# Technical Service Bulletin

**MODEL(S)  
AFFECTED:** **M17**

**SUBJECT:** Vacuum fan(s) turning off after a few minutes of operation. Error code 520 (static discharge interfering with vacuum fan operation) appears in the display when the vacuum fan(s) stop operating.

**PURPOSE:** Update machines to eliminate problems causing error code 520 to occur.

FIG. 3 - Harness, Ele [Static Gnd, M17] / Plate, Fan, Guard

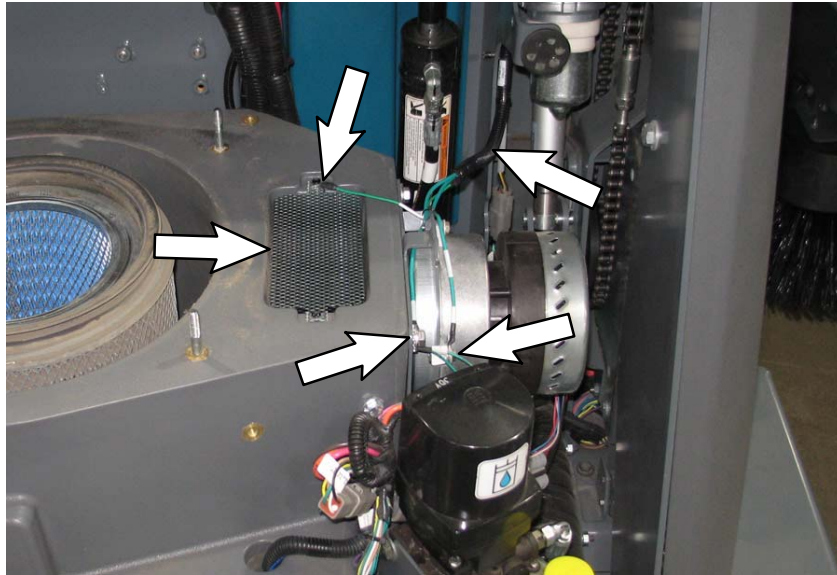
1. Check sweep board revision number. The sweep board should be labeled revision 01. Machines above serial number M17- 10293 already have this circuit board installed. Replace sweep board if it is labeled revision 00 (machines serial numbers below M17- 10293). (Fig. 1 / Fig. 2)  
If a new Sweep Board is required, order Circuit Board Kit, Swp, Side, Afmkt [M17] - Kit Number 9015048. The IB for this kit is IB 9015110.
2. Use Service Diagnostic Tool to check software revision. If necessary, update to latest software revision.
3. Check if vacuum fan static harness / fan guard are installed. Machines above serial number M17- 10271 already have the vacuum fan static harness / fan guard installed. Install vacuum fan static harness kit onto machines serial numbers below M17- 10271. (Fig. 3)

*Note: Machines serial numbers M17- 10240 through M17- 10271 may have an incorrectly installed static harness. If this harness is installed, and is not connected directly to a thread roller in the frame (connected to the hopper down switch bracket instead), it should be replaced.*

If a vacuum fan static harness / fan guard are required, order Harness Kit, Vac Fan, Afmkt [Static Ground] - Kit Number 9015386. The IB for this kit is IB ~~9015386~~ **9015268**
